Delegated Report		Analysis sheet	Expiry Date:	20/01/2021
		N/A	Consultation Expiry Date:	07/02/2021
Officer			Application Number(s)	
David Peres Da Costa			2020/5481/P	
Application Address			Drawing Numbers	
69 St Augustine's Road London NW1 9RR			Refer to draft decision notice	
PO 3/4	Area Team Signature	C&UD	Authorised Officer Signature	
Proposal(s)				
Erection of rear dormer and rooflights to the side roof slope.				
Recommendation(s):		Refuse planning permission		
Application Type:		Full planning permission

1.1. The application seeks approval for a rear dormer and rooflights in the side roof slope.

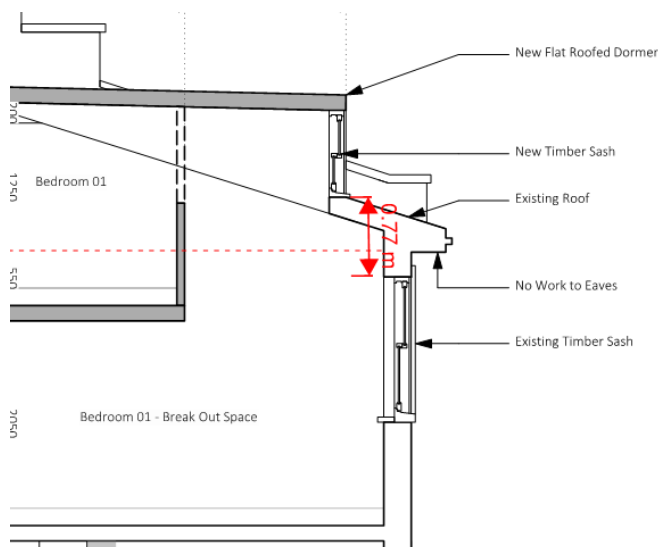
2.6. The gap between the proposed dormer and both the roof hip (approx. 0.36m) and the party wall (approx. 0.22m) would be relatively narrow. It is also unclear whether the roof has been properly surveyed as the roof ridge measures approximately 1.74m in the submitted drawings but measures approximately 1m when measured using the aerial photography layer of the Council's GIS system (as shown in the image below).
